# AIA<sup>®</sup> Document G709<sup>™</sup> – 2018

## Proposal Request

# PROPOSAL REQUEST 047

## Gallery Handrail and Steps

**6 | 104 PUBLIC GALLERY - RISERS**  
1/4" = 1'-0"

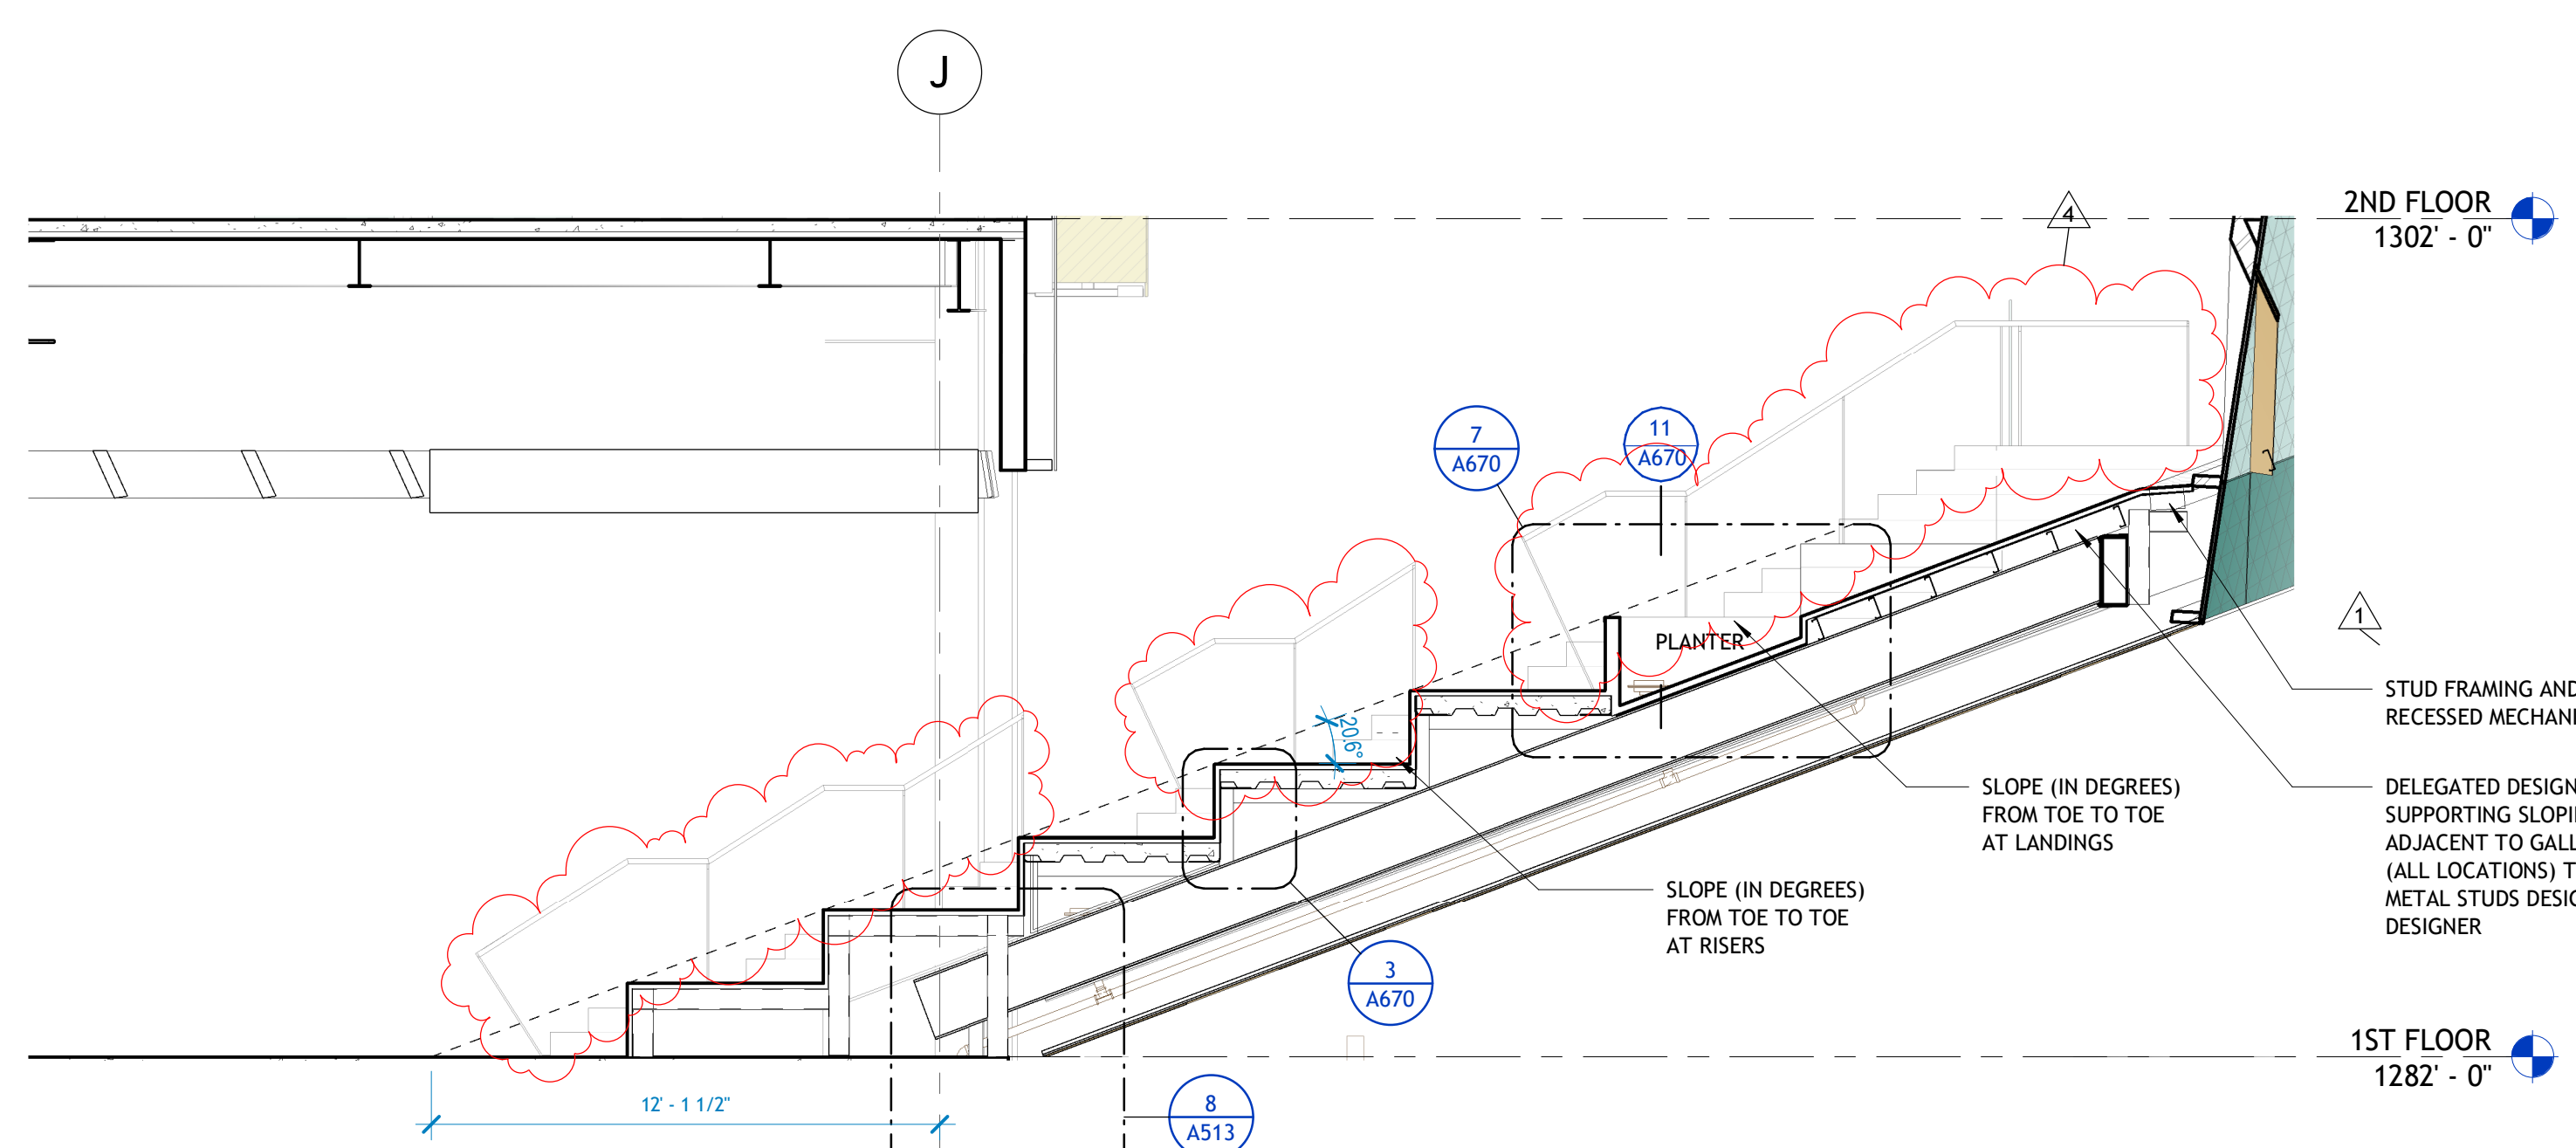
- a) Refer to Revised Sheet **A606 – ENLARGED STAIR PLANS – PUBLIC GALLERY** with original issue date 02.24.2023 and revision date **06.05.2024**.
  - **Detail 1:**
    - (1) Revise spacing of upper section of steps.
    - (2) Add new section through steps for guardrail elevation.
    - (3) Revise width of stud framed steps, leaving 4 ½" on each side from edge of landings.
    - (4) Extend lowest seating riser towards door.
  - **Detail 5:**
    - (1) Updated appearance of handrail
    - (2) Revised spacing of upper section of steps.
    - (3) Added Detail at top landing.
  - **Detail 6:**
    - (1) Updated appearance of handrail

**7** 1101 GALLERY RISERS - TYPICAL PLANTER SECTION  
1 1/2' x 1'-0"

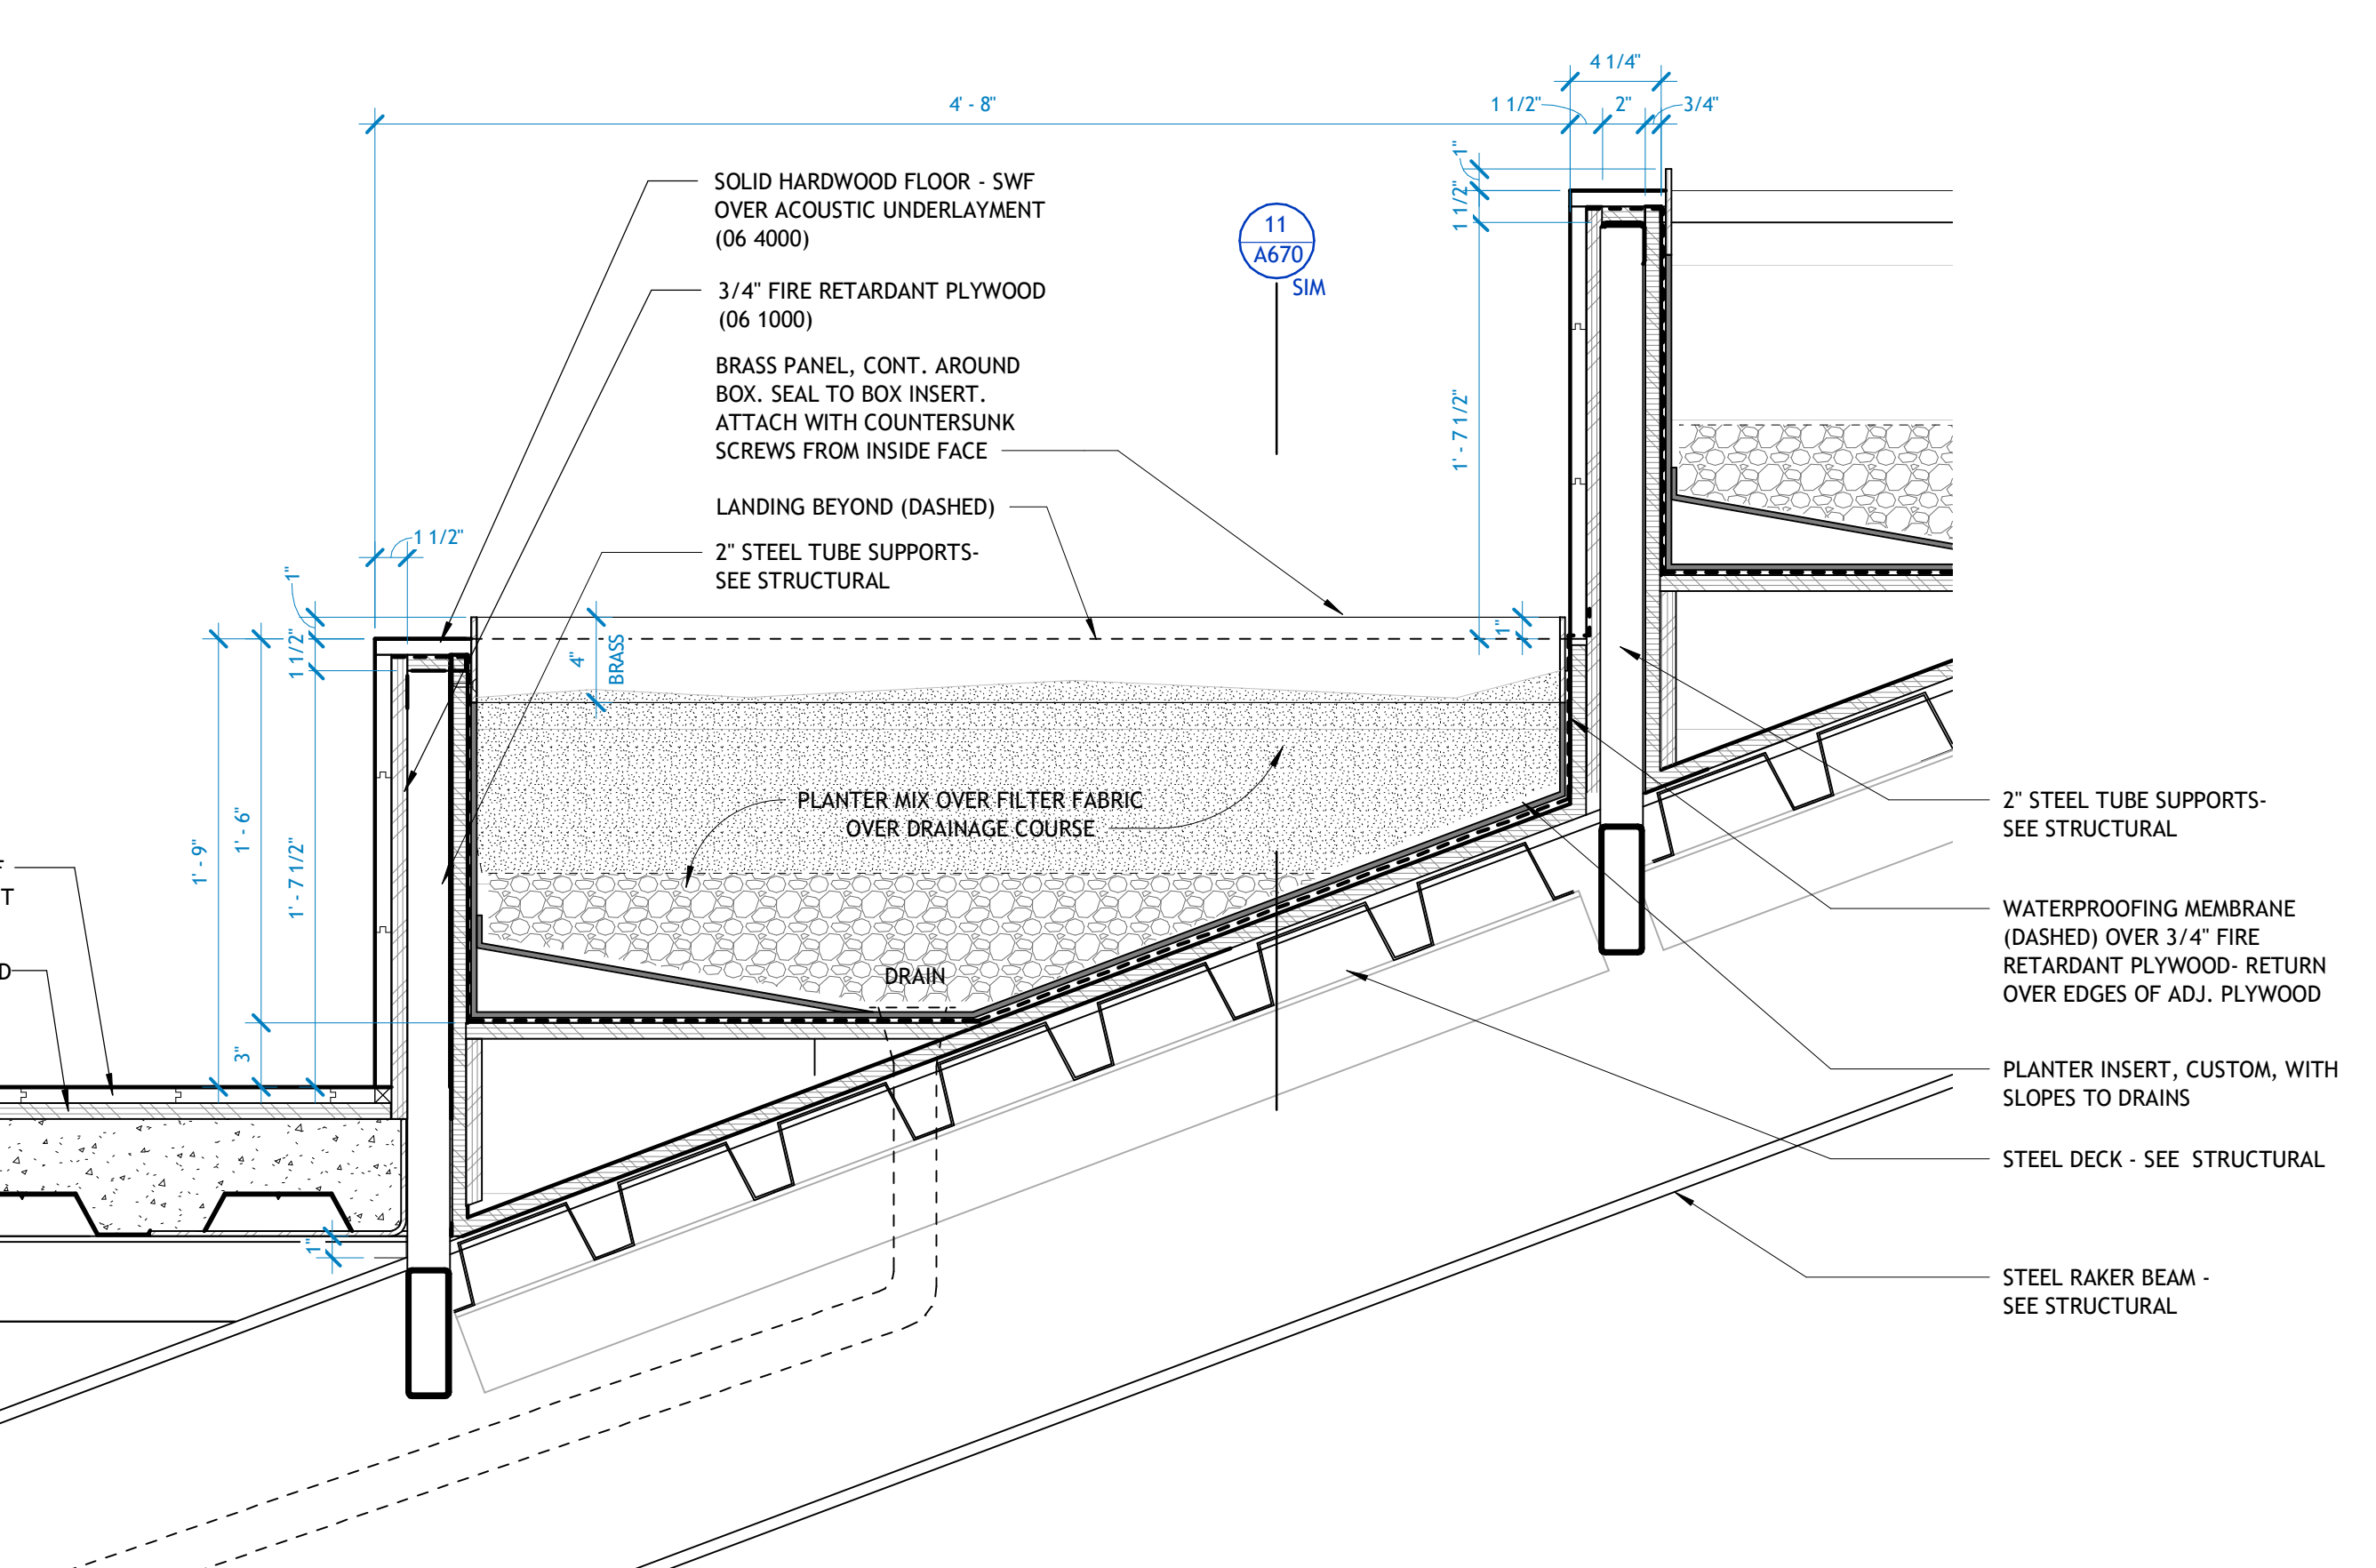
- b) Refer to Revised Sheet **A670 – INTERIOR DETAILS – GALLERY RISERS** with original issue date 02.24.2023 and revision date **06.05.2024**.
- **Detail 7:**  
(1) Added gallery handrail return and notes.

**11** 1101 GALLERY PLANTER, LENGTH  
1 1/2' x 1'-0"

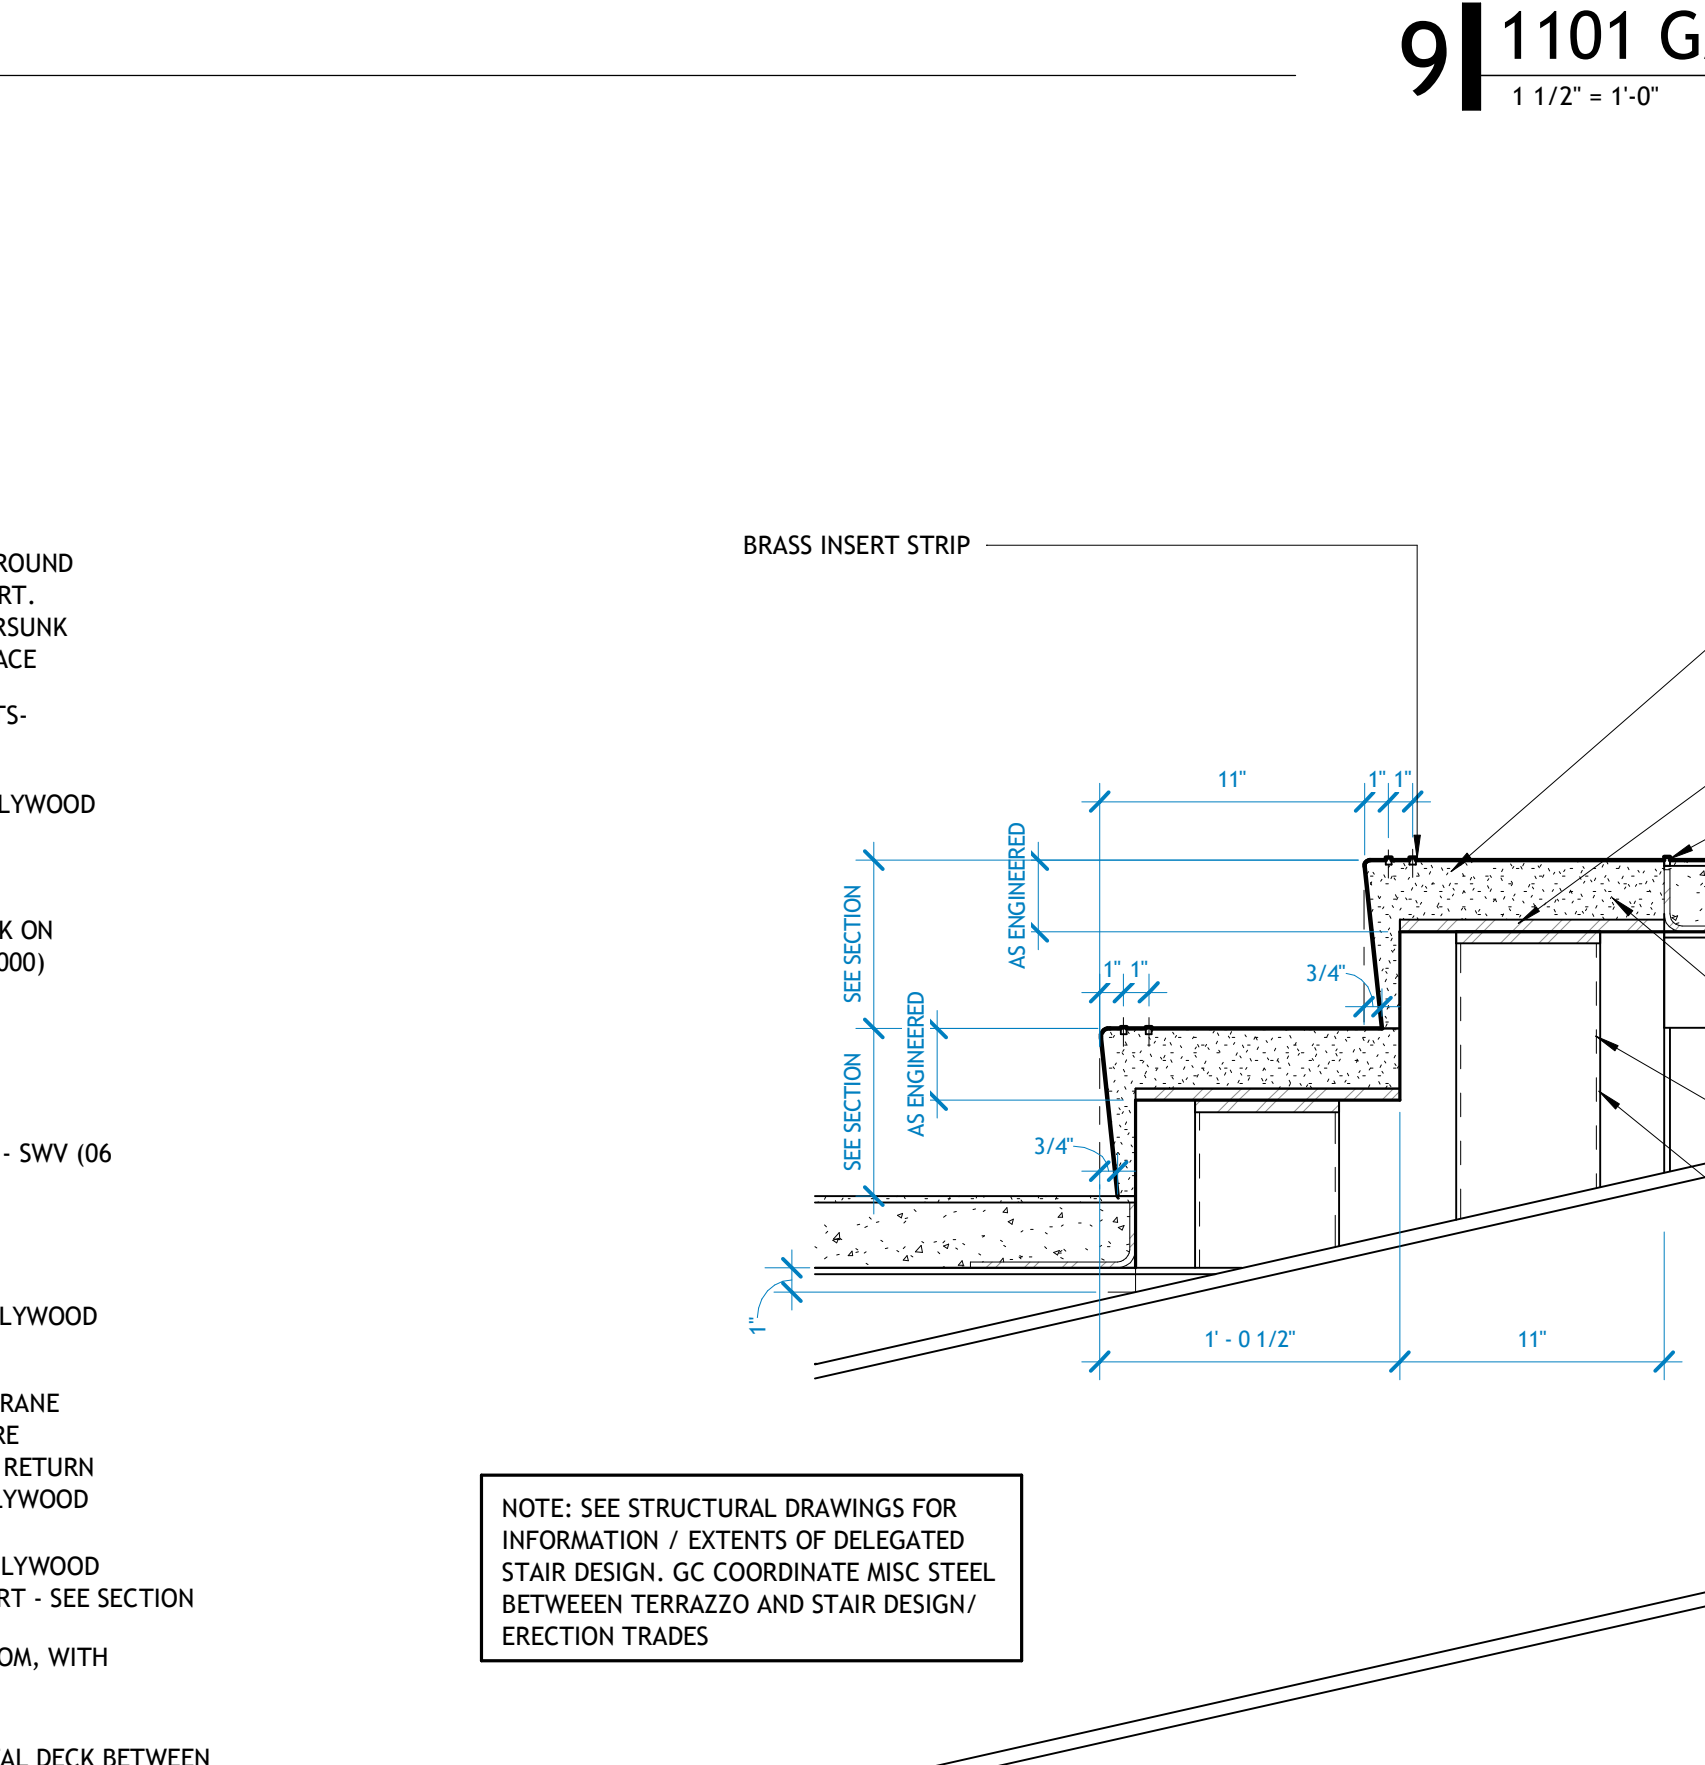
- **Detail 11:**  
(1) Revised detail to pull back stair from edge of slab, allowing for bypass of handrail supports.
- c) Refer to **NEW** Sheet **A670B – INTERIOR DETAILS – GALLERY RISERS** with original issue date **06.05.2024**.
- New Sheet with 3D view, gallery handrail elevation, and additional details
